SUBJECT: Forwards request for license amend to clarify pressure testing requirements for isolable & non-isolable diesel fuel oil piping based on guidance provided in ASME Code Section XI.W/one oversize drawing.

SHEARON HARRIS NUCLEAR POWER PLANT
DOCKET NO. 50-400/LICENSE NO. NPF-63
REQUEST FOR LICENSE AMENDMENT
DIESEL FUEL OIL SYSTEM PRESSURE TESTING (A.C. SOURCES - OPERATING)
ADDITIONAL INFORMATION

Attachment 1
Request for License Amendment
Diesel Fuel Oil System Pressure Testing
Additional Information

DIESEL FUEL OIL SYSTEM SCHEMATIC
 PIPING EXEMPT FROM 110% PRESSURE TEST
 (TYPICAL)

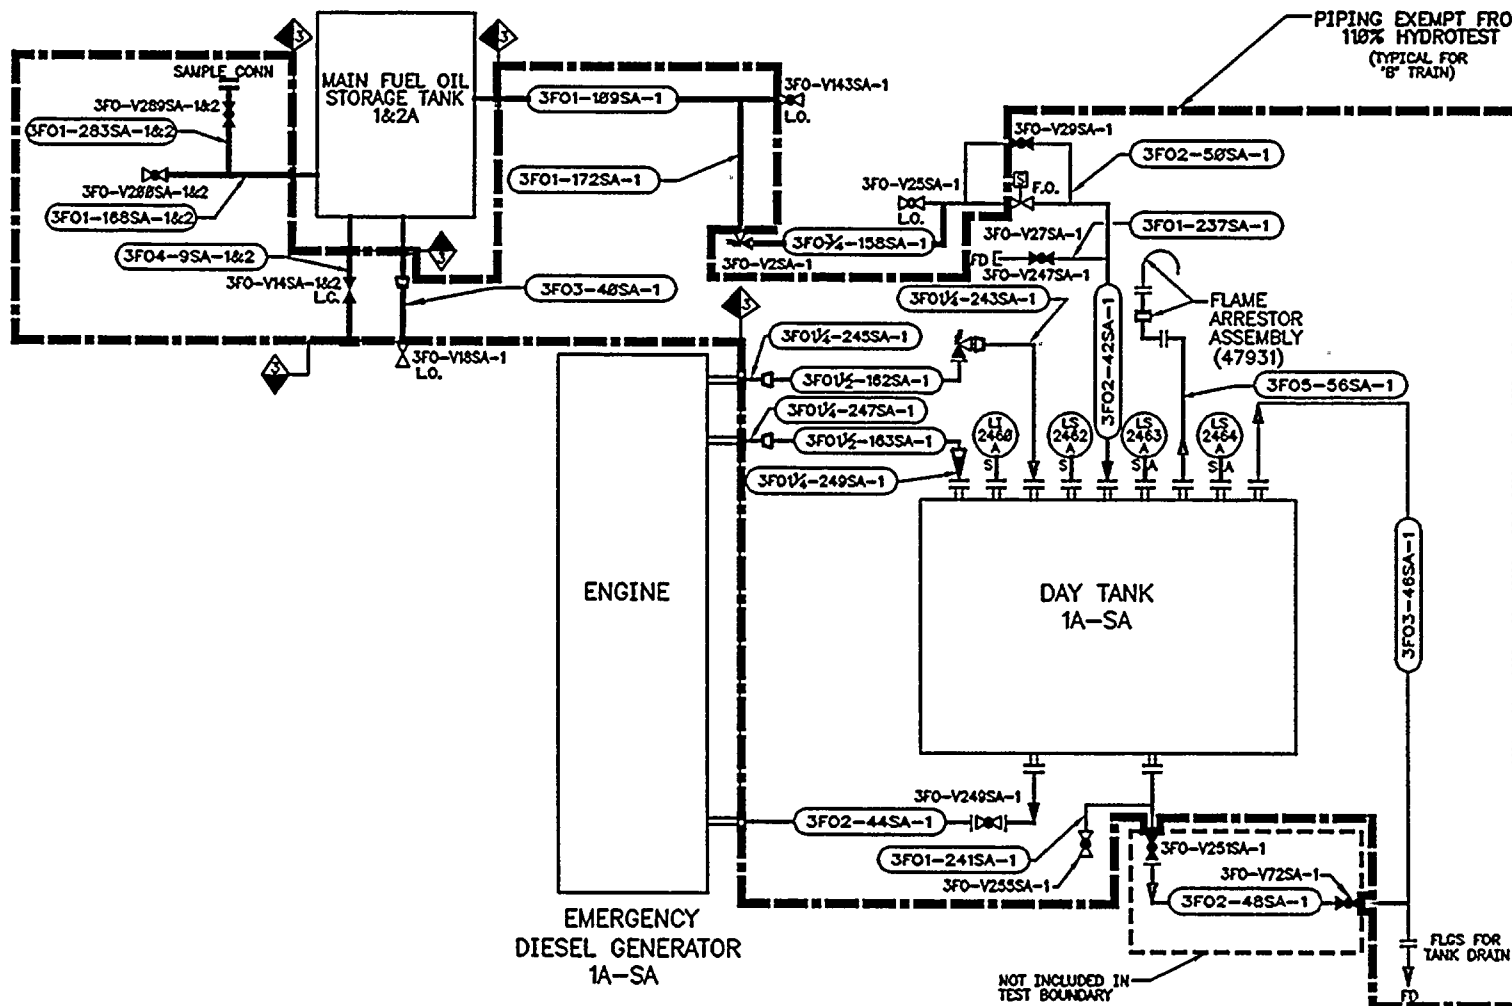
Subarticle IWD-5223, Item (b) states that "In the case of atmospheric storage tanks, the hydrostatic head, developed with the tank filled to its design capacity, shall be acceptable as the test pressure." The Fuel Oil Day Tanks 1A-SA and 1B-SB are atmospheric tanks and are therefore addressed by this section and would not require a 110% pressure test. The day tanks are above ground and can be visually inspected for leaks during normal operation.
(Please reference the "purple" color-coded portions on Attachment 2)

Subarticle IWD-5223, Item (c) states that "For the purpose of the test, open ended portions of suction or drain lines from a storage tank extending to the first shutoff valve shall be considered as an extension of the storage tank." The fuel oil lines from the atmospheric day tanks to the first shutoff valve and several lines extending from the day tanks are addressed by this section and therefore would not require a 110% pressure test. These lines can also be visually inspected during normal operation.

3FO1 ¼-249SA-1	3FO1-109SA-1
3FO1 ½-163SA-1	3FO1-283SA-1&2
3FO3-40SA-1	3FO1-168SA-1&2
3FO2-42SA-1	3FO4-9SA-1&2
3FO1-237SA-1	3FO1 ¼-247SA-1
3FO2-50SA-1	3FO2-44SA-1 (between isolation valve and day tank)
3FO1-172SA-1	3FO1-241SA-1
3FO1 ¼-247SA-1

Subarticle IWD-5223, Item (e) states that "Open ended vent and drain lines from components extending beyond the last shutoff valve and open ended safety and relief valve discharge lines shall be exempt from the hydrostatic test." The vent, drain and relief valve lines associated with the day tanks are addressed by this section and therefore should be exempted from the 110% hydrostatic test.

3FO3-46SA-1
3FO5-56SA-1
3FO1 ¼-243SA-1

3. A portion of the fuel oil supply and return lines between the diesel engine vendor supplied piping and the day tanks can not be externally pressurized and isolated and will therefore be tested in accordance with the Alternative Rules for 10-year System Hydrostatic Testing for Class 1,2 and 3 Systems (Code Case N-498-1)

3FO1 ½-162SA-1
3FO1 ¼-245SA-1
3FO2-44SA (between engine and isolation valve)

4. Table IWD-2500-1, Item D2.10, Note (1) states that "The system boundary extends up to and including the first normally closed valve or valve capable of automatic closure as required to perform the safety-related system function." Since the day tank floor drain isolation valves (3FO-V251SA-1 and 3FO-V72SA-1) are normally closed, line 3FO2-48SA-1 will not be included in the test boundary.

3FO2-48SA-1
